Application Ref: SMD/2022/0076

RE: LAND OFF BERMERSLEY ROAD, BROWN EDGE

Thank you for your response to the planning application submitted to Staffordshire Moorlands District Council (SMDC) (ref. SMD/2022/0076). The application is for construction of a Battery Energy Storage System (BESS) facility and will include the installation of battery containers, adjoining inverter and transformer containers, a customer substation, security fencing, landscaping and other associated infrastructure.

HYDORBRAKE MANHOLE DETAIL
1:20

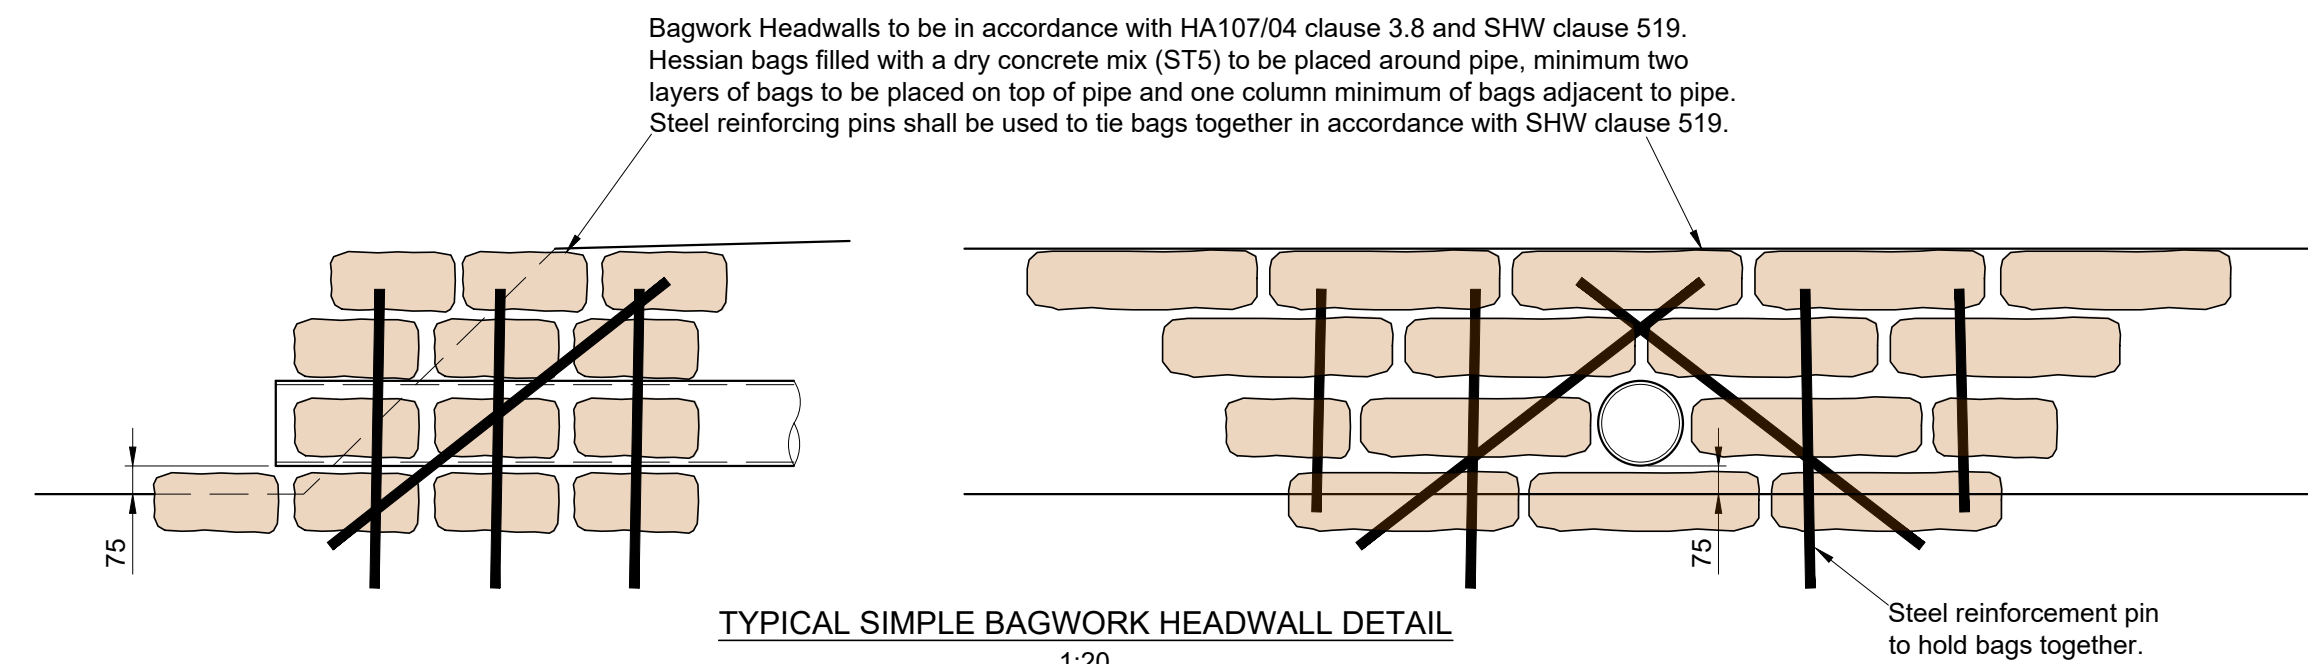
- Drainage Strategy
 - Ground levels
 - Details of the connection between the swales
 - Proposed connection details from the swale into the ditch
 - Point of Discharge

- We need to see the design for the replacement culvert and, as above, be assured that it will have sufficient capacity to convey the required flows and volumes.

The connection detail from the swale into the existing ditch will be via a 150mm diameter pipe with bagwork headwalls at both the swale and ditch connection points, a flow control manhole is provided on the discharge route with a hydrobrake limiting the discharge from the site to 0.5l/s. The discharge route is shown on drawing 01 with details of the headwalls, pipe bedding and flow control chamber included on drawing 02.

TYPICAL SECTION THROUGH ACCESS TRACK
1:20

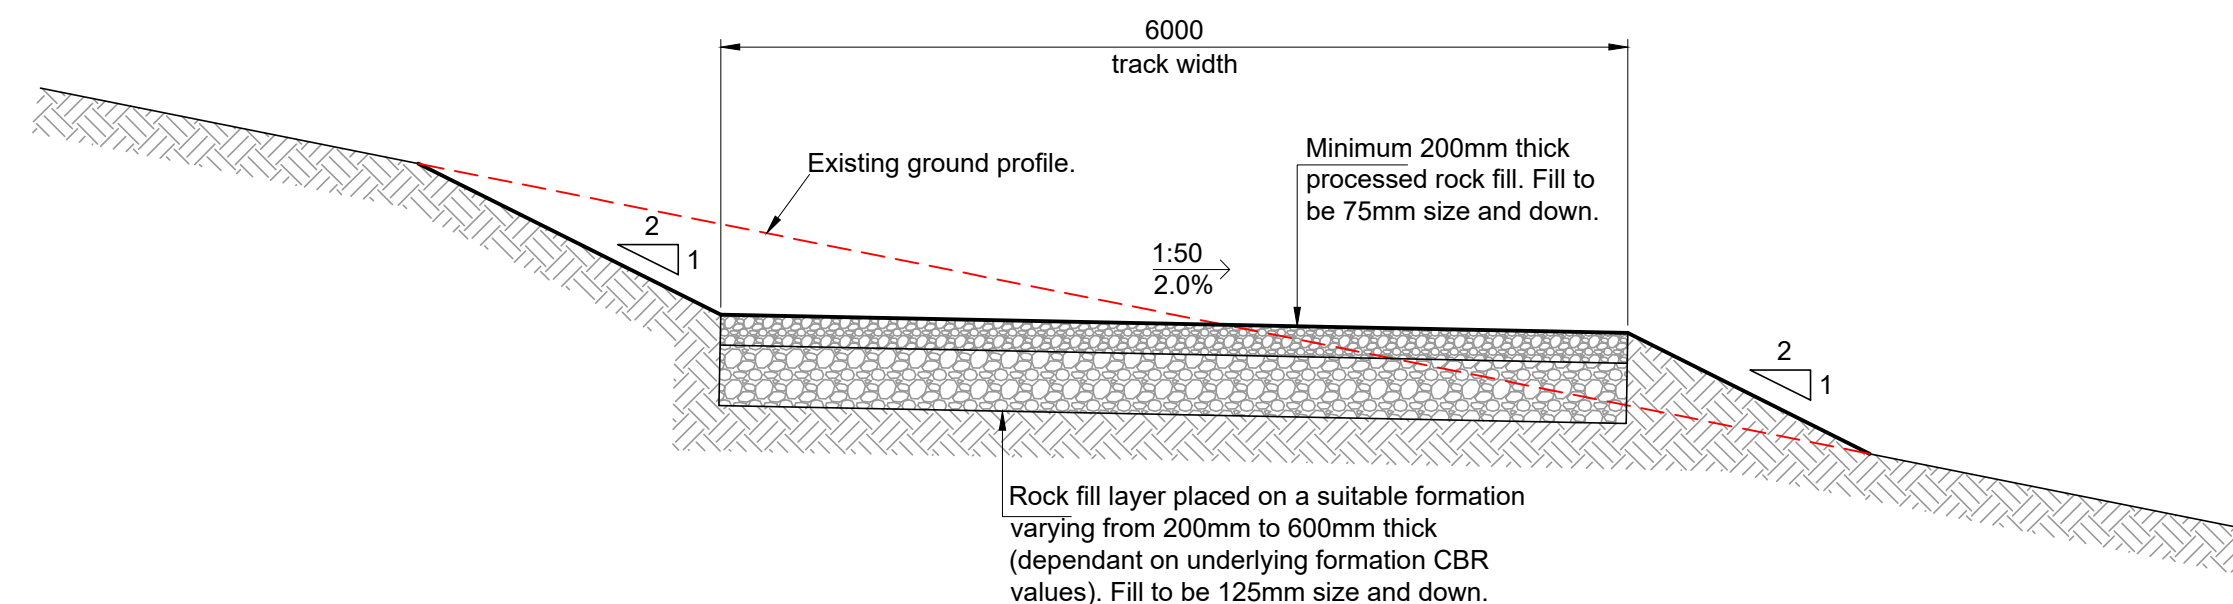
- Permeable Surfacing
 - Please provide build ups of the proposed permeable surfacing for the access tracks and vehicle movement areas.
 - Rainwater Harvesting

A typical section through the access track is provided on drawing 02, the fall on the road and vehicle movement areas will be set to shed water to the existing ground.
